SKILLING, HELLE, CHRISTIANSEN, ROBERTSON — Structural & Civil Engineers

PROJECT: THE WORLD TRADE CENTER | TITLE: TEL/CO REVISIONS- TOWER B FL. 11&12 | DATE: 7-9-71

Col. Nos. 151, 153, 307, 309 Fl. 11 & 12
See Dwg. 68330-A-106 & A-107

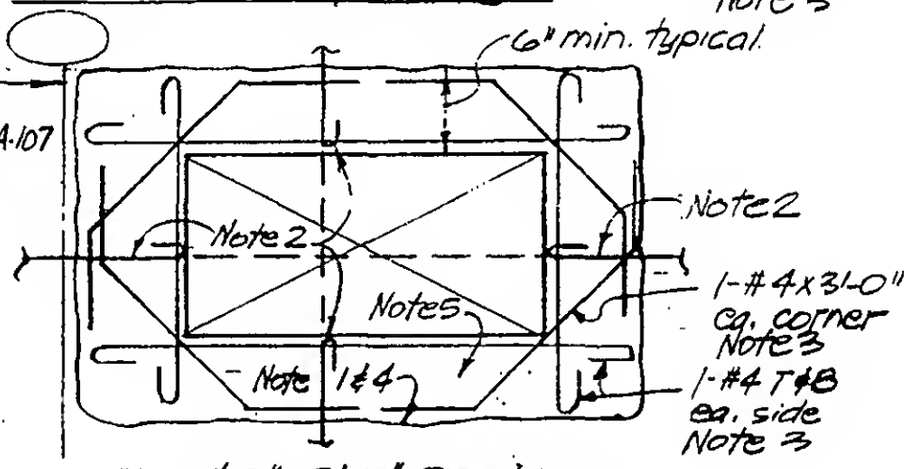
1'-0" x 4'-0" openings

Notes:
1. Remove existing concrete to line indicated without damaging existing reinf.
2. Cut existing reinf. and hook at edge of opening.
3. Add new reinf. as indicated.
4. Clean face of exist. concrete and thoroughly coat entire surface with epoxy bonding compound.
5. Cast slab to edge of new opening using approved "non-shrink" fc = 4000psi concrete.
6. Slabs to be shored as required before removing exist. concrete.

Col. 223, 239, 246 Fl. 12
See Dwg. 68330-A-107

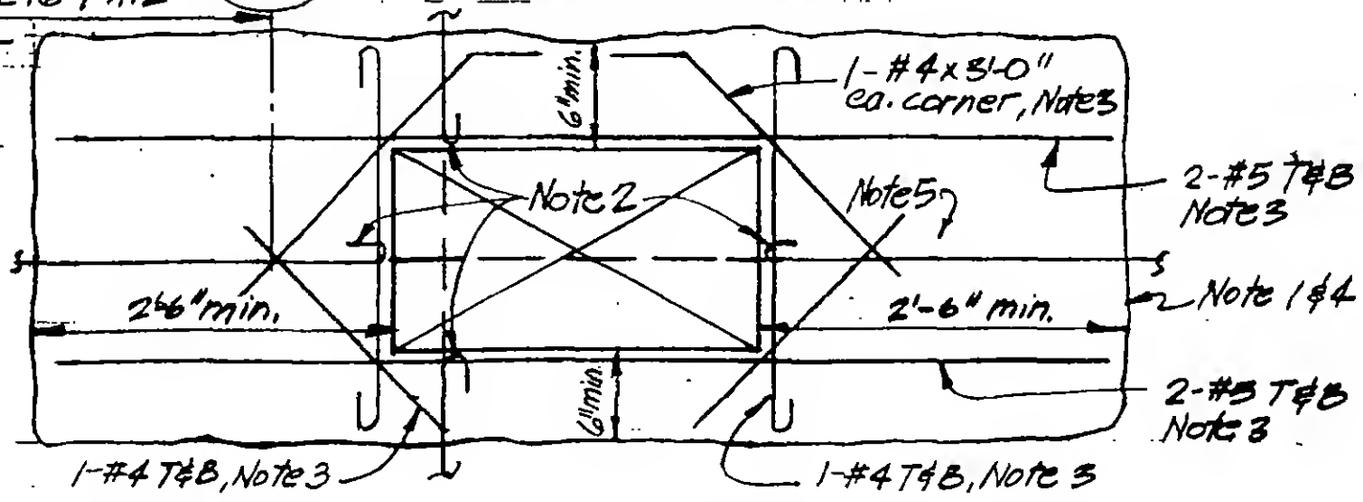
1'-0" x 2'-0" Opening
Floor 12 as noted
